UNITED STATES PATENT AND TRADEMARK OFFICE

APPLICATION NO.	FILING DATE	FIRST NAMED INVENTOR	ATTORNEY DOCKET NO.	CONFIRMATION NO.
09/936,117	02/01/2002	Thomas Hoffer	P/2107-186	9525
2352	7590	05/19/2004	EXAMINER	
OSTROLENK FABER GERB & SOFFEN 1180 AVENUE OF THE AMERICAS NEW YORK, NY 100368403			TSANG FOSTER, SUSY N	
			ART UNIT	PAPER NUMBER
			1745

Office Action Summary	Application No.	Applicant(s)	
	09/936,117	HOFER ET AL.	
	Examiner	Art Unit	
	Susy N Tsang-Foster	1745

DETAILED ACTION

Figure 33 (f)

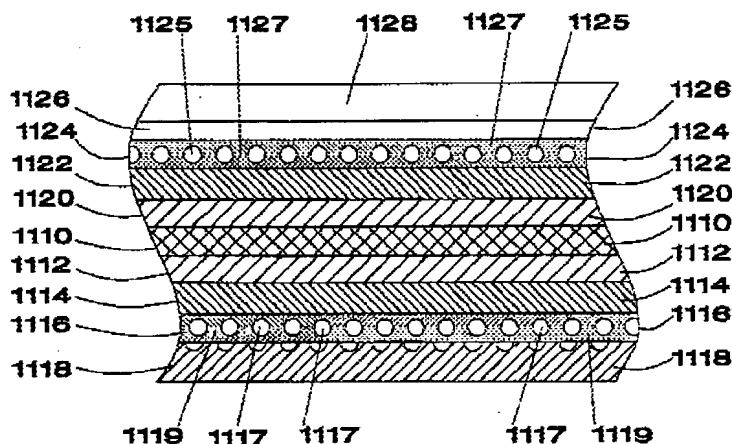
Dodge discloses a tubular composite comprising a braid of metal wires (which are filaments) and a layer of ion-conducting material arranged above it (see Figures 33a-33f; col. 32, line 51 to col. 35, line 48). See especially Figure 33 (f) reproduced below:

Figure 33(f) shows a polymer exchange membrane electrolytic member 1110 (which is an ion-conducting material) is disposed as the central layer of the tubular composite, an anode catalyst layer 1112, an anode gas diffusion layer 1114, an anode collection layer 1116, a cathode layer 1120, a cathode diffusion layer 1122, a cathode collector 1124, and outer housing member 1128 (col. 33, lines 9-22). The center of the tubular composite is by definition the lumen.

The current collectors 1116 and 1124 can be in the form of braided metal wires in tubular form (col. 34, lines 16-20). The braided metal wires form an electron-conducting woven support. The current collectors collect electrical current from the tubular composite such that it would be in electrical conductive contact with an electron-conducting device to which the tubular

The porous catalyst layers 1112 and 1120 are preferably thin coatings and provide a distinct gas-dissociation stage in intimate contact with electrolytic member 1110 (the ionic conducting material; see col. 33, lines 33-38). The porous catalyst layers comprise a finely divided catalyst, such as platinum in a conductive medium such as carbon black (col. 33, lines 23-44). Typically, catalyst layers also contain TEFLON, which is polytetrafluoroethylene (PTFE) and hydrophobic, serving as a binder for the platinum particles and as a hydrophobic agent to prevent the accumulation of water in the catalyst layer (col. 7, lines 45-50).

Alternatively, to enhance conductivity and reduce resistance in every feature of the fuel cells' electrical construction, the catalyst layer can also comprise platinum and a conductive proton-exchange polymer (col. 22, lines 35-58). In the case where the catalyst layer comprises a conductive proton-exchange membrane, it would function as an ion-conductive spacer between the first braided current collector (innermost tubular component) and the ion-conducting material of the electrolytic membrane and the second catalyst layer comprising a conductive proton-exchange membrane would function as an ion-conductive spacer between the outermost braided current collector and the ion-conducting material of the electrolytic membrane.

Fig. 13

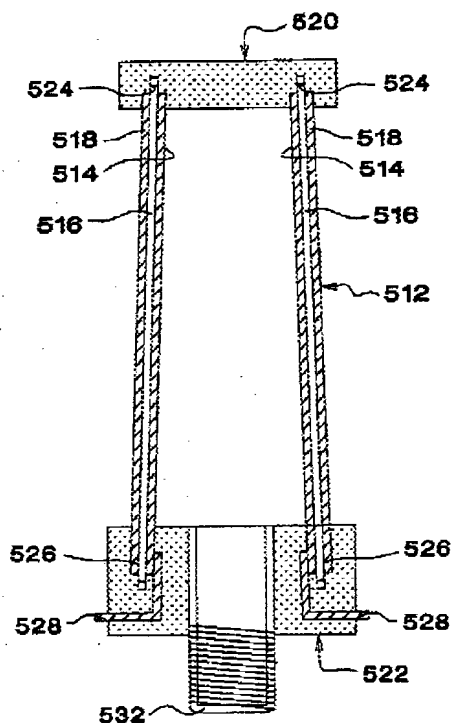
Dodge discloses a tubular composite 512 comprising a braid of carbon fibers (woven carbon cloth) and a layer of ion-conducting material arranged above it (see Figure 13 and col. 36, lines 32-52). See especially Figure 13 reproduced below:

Figure 13 shows inner anode 514, outer cathode 518, and electrolyte membrane 516 (col. 11, lines 17-32). Another embodiment of Figure 13 employs a plurality of tubular member composites 512, for example from two to ten members with alternating anode-cathode dispositions in a radial direction and suitable spacing between members such as inactive insulative supports (col. 12, lines 3-9). The resultant array of nested sleeves is adapted to supply hydrogen to alternate spaces between anodes, in a non-leaking manner (col. 12, lines 9-10).

The tubular fuel cells can be connected either in series or in parallel, depending upon whether the voltage or current capacity is desired (col. 13, lines 5-10). Each of the electrode 514 and 518 is self supporting and substantially rigid and deposits of platinum catalysts deposited on the appropriate electrode surface in the vicinity of the surfaces mating with the electrolyte membrane (col. 13, lines 10-26). Where the concentric tubular members comprise carbon fibers, derived for example from woven carbon cloth, exceptional tensile strength and conductivity is provided in a light weight structure (col. 36, lines 32-52).

The woven carbon cloth in each of the electrodes of the tubular composite which is electrically conductive would be in electrical conductive contact with an electron-conducting device to which the tubular composite designed as a fuel cell is connected to provide power. As seen in Figure 13, a metal conductor 528 is in contact with the lumen of the tubular composite (col. 12, lines 52-67). Electricity is tapped from connectors 528-530 as seen in Figure 14.
